TECH TIP 009

OAP7144

OPEL & VAUXHALL 1.4 PETROL

FIG. 1

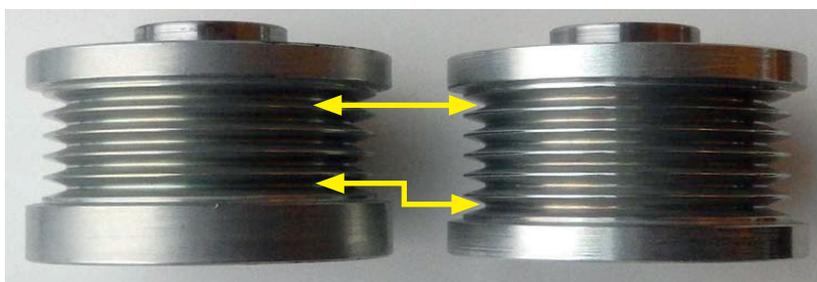
On certain Opel/Vauxhall engines (codes: A14NEL, A14NET, A14XEL, A14XER) the belts may have 5 or 6 ribs while the pulleys may have 5 or 6 grooves. It depends on the manufacturing date of the car. Gates recommends replacement of a 5 groove OAP (Fig.1 left side) with the 6-grooved OAP7144 (Fig. 1 right side).
